## Technical Report

No. 13618

### Engineering Evaluation of the MEMCOR Small ROWPU

SUBJECT: Safety and Health Assessment of MEMTEC America Corp., MEMCOR Div. 3 GPM, Reverse Osmosis Water Purification Unit (ROWPU), Serial No. 5048, built for USAF STRATCOM

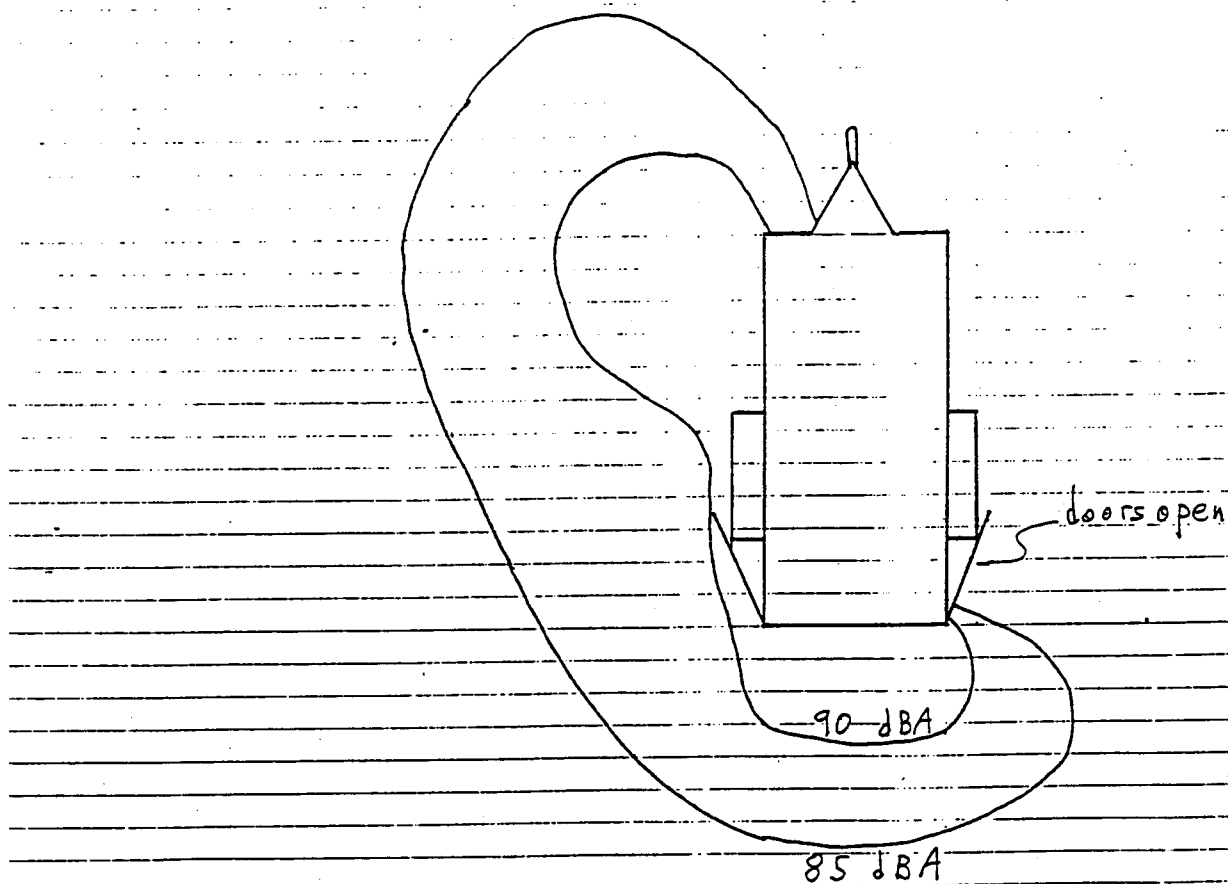
4. Acoustical Noise - Para 3.3.6.1.
  - a. Exterior noise levels of 85 dBA extend a maximum distance of 11 feet 6 inches from the exterior of the trailer with all doors open. For 85 and 90 dBA noise contours, see Encl 1.

Figure 1. Display heights. This front view sketch is not to scale. The generator gauges are directly above the meters and switches deep under the RO vessels.

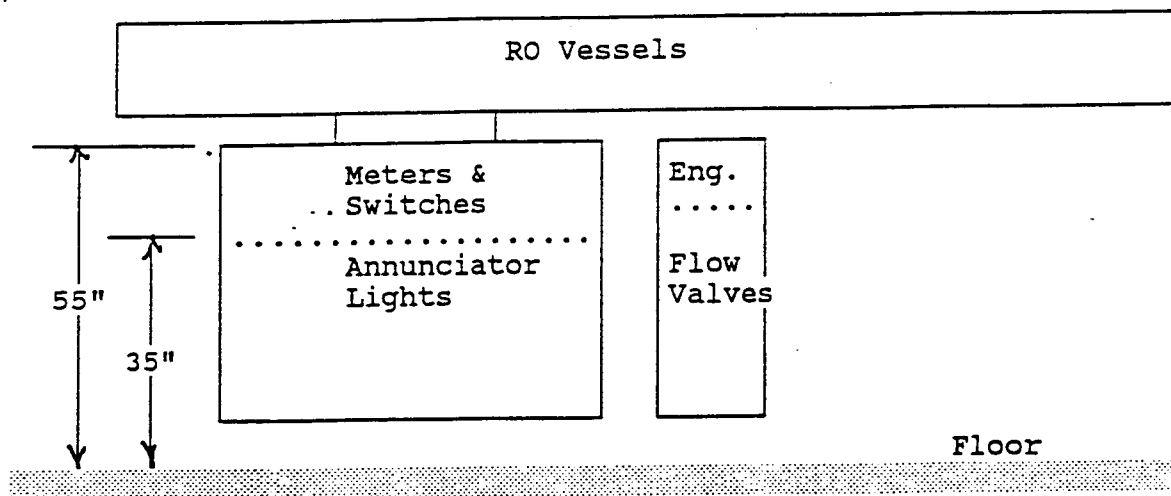
m. Controls are not located at eye height (see Figure 1). The engine portion is not labeled properly. Illumination on the control panels is wholly insufficient and poorly distributed. The generator meters are buried under the Reverse Osmosis (RO) vessels and have scales that are hard

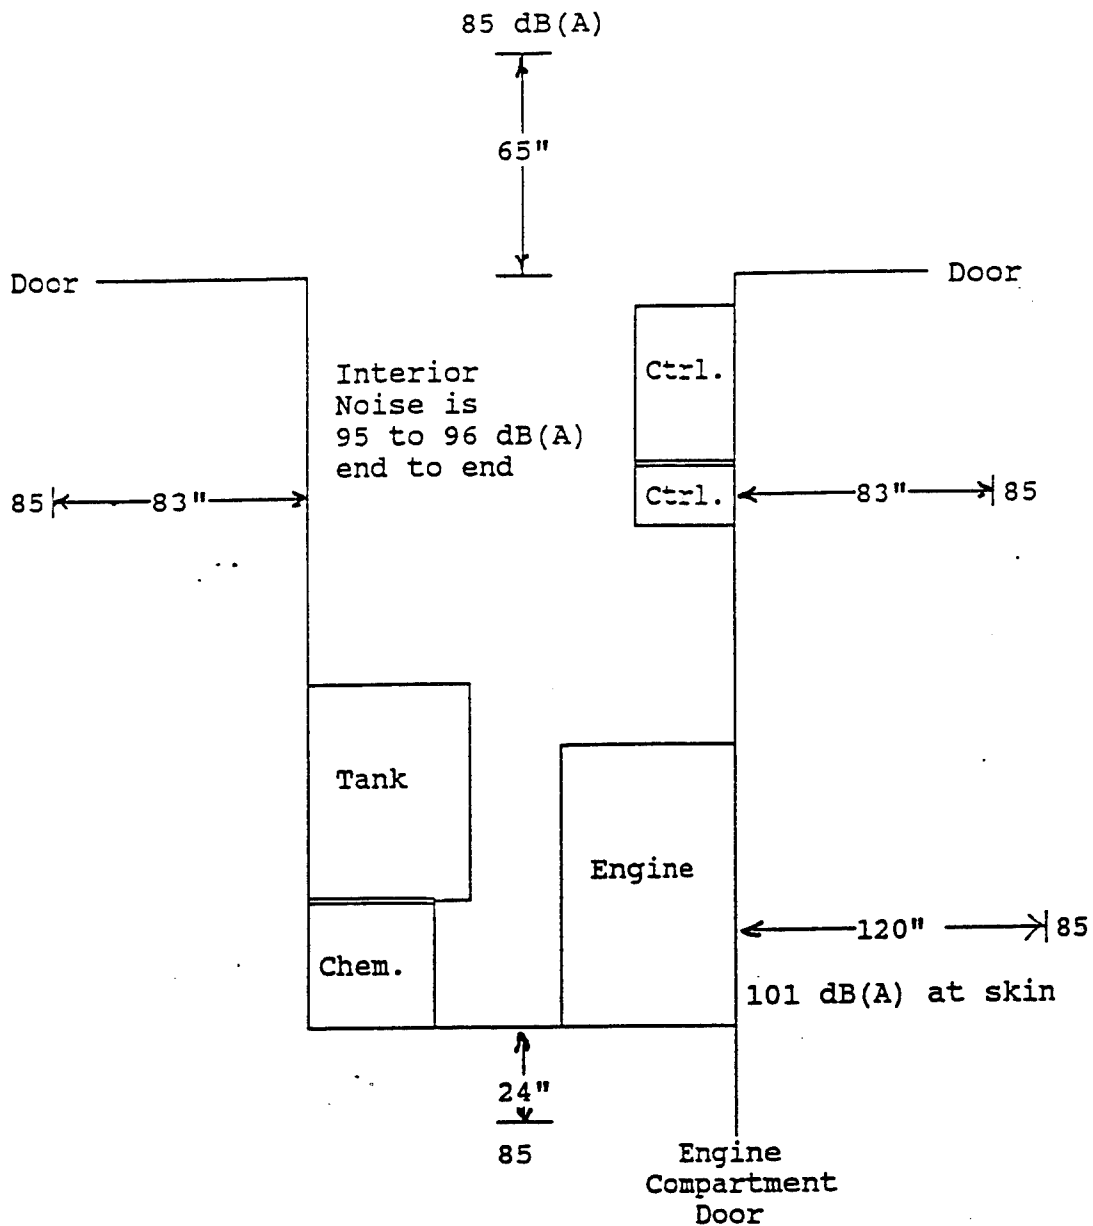
a. Figure 2. lists internal and external noise levels which vastly exceed MIL-STD-1474C (Tri-Service) requirements. Interior levels of 95 to 96 dB(A) cause a 23% hearing damage risk level. Exterior levels also exceed the commonly required 85 dB(A) at 1 meter level. Hearing damage hazard signs are not posted. Thus, personnel are not warned of the hazard. Hearing loss compensation cost the Army more than \$2 billion since 1968. So, controlling the hazard at the source, rather than hoping that warning signs will suffice, is prudent.
